City Council Meeting 12.03.25

RE: Project Update and Council Direction –
Cedar Street Reconstruction, Lincoln Ave. to
Division Ave.

Option #2 - Continual Multimodal Path on the Southside - Replacing existing sidewalk

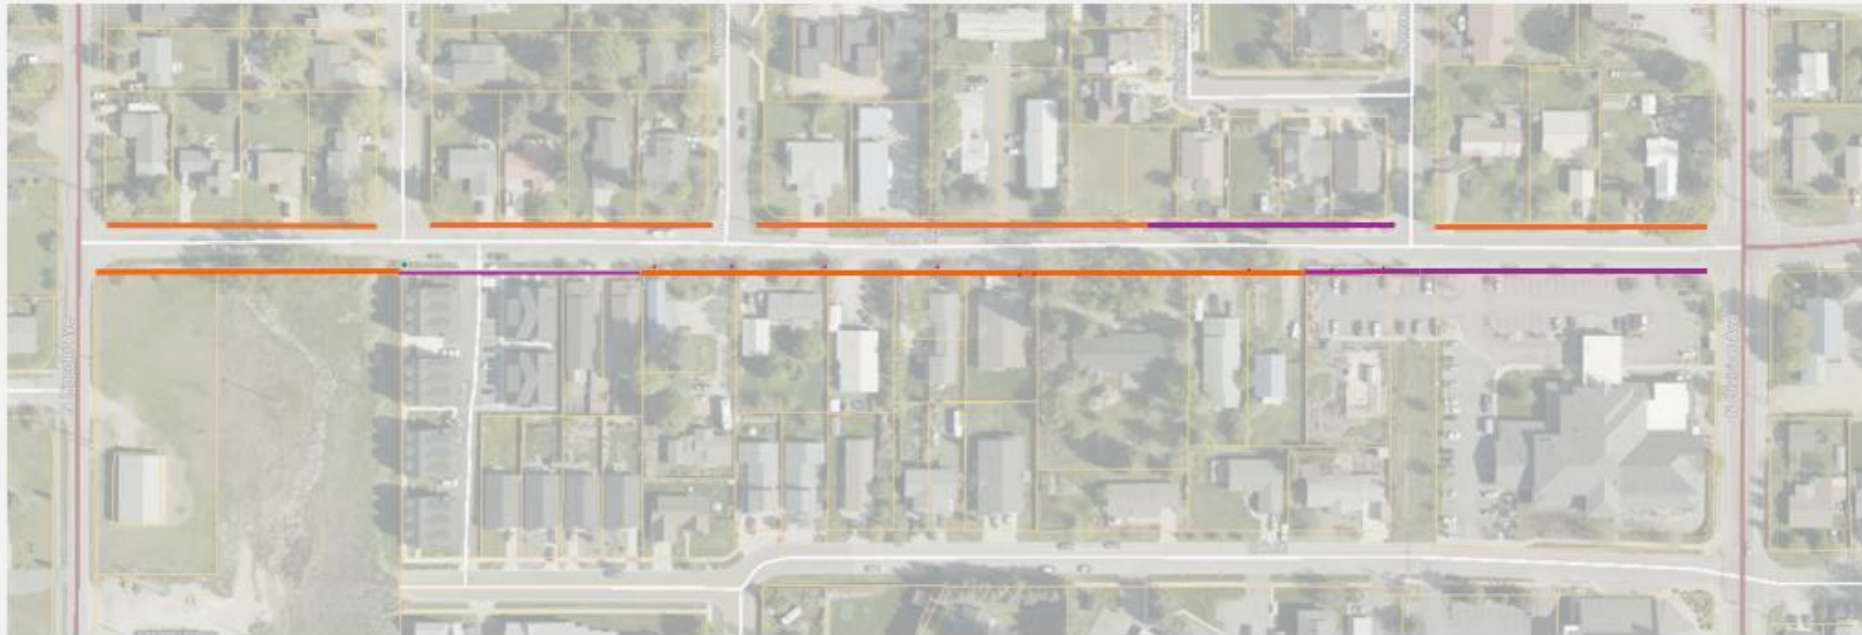
- Staff met with Design Engineer, recommends – *either continuous multimodal path or continuous sidewalk*
- Identified power pole located directly in the middle of the proposed the 10ft wide multiuse path
 - 7 between N. Monroe Ave to Division Ave – Option #1
 - 9 between N. Madsion Ave to Division Ave – Option #2
